# 1968 Corvette: Service Bulletin: Heat Damage to Engine Wiring Harness at Starter Solenoid

**Model and Year:** 1968 Corvette with 396 or 427 Cubic Inch Engine

**Bulletin No:** 68-T-66

Figure 1

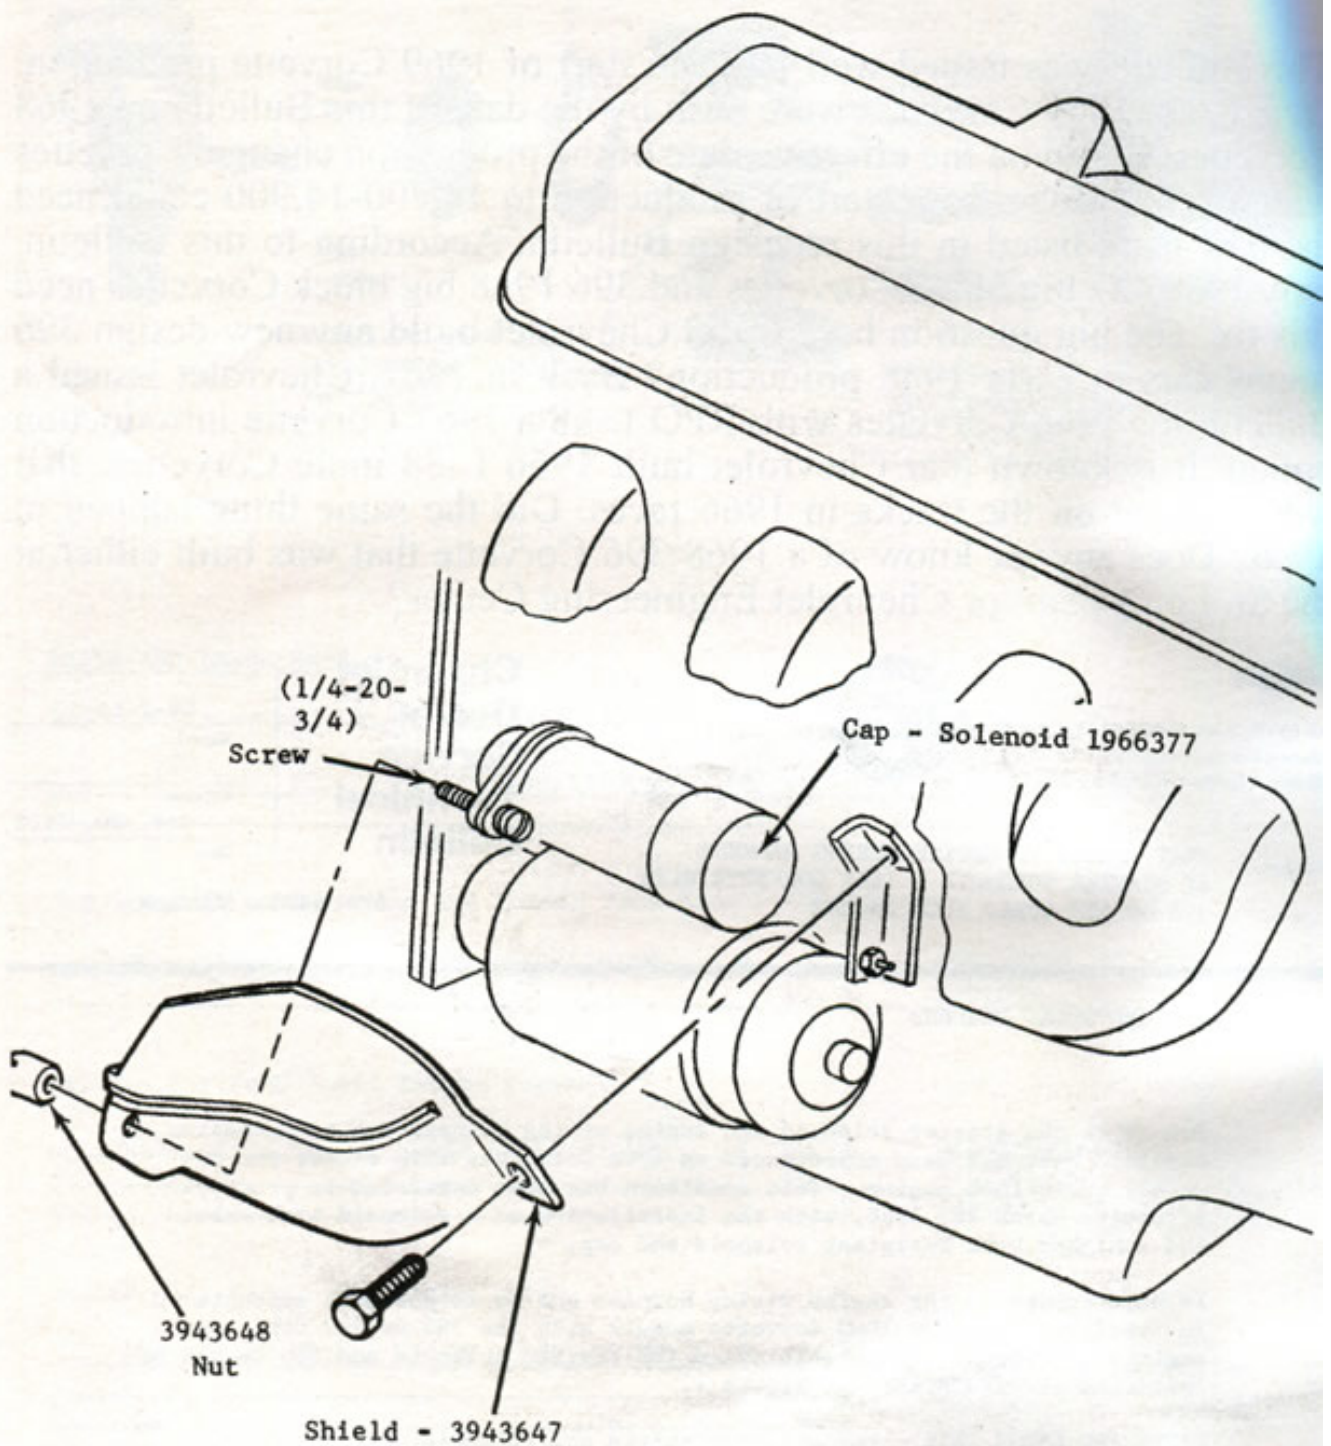
Damage to the starter solenoid and engine wiring harness due to excessive manifold heat has been experienced on 1968 Corvettes with either the 396 or 427 cubic inch engine. This condition has been corrected in production effective March 28, 1968, with the installation of a solenoid heat shield and a higher heat resistant solenoid end cap.

If heat damage to the engine wiring harness and/or solenoid is encountered in the field on early 1968 Corvette models with the 396 or 427 cubic inch engine, the solenoid heat shield and the revised solenoid end cap should be installed as illustrated in figure 1.

Installation of Heat Shield  
and Solenoid Cap
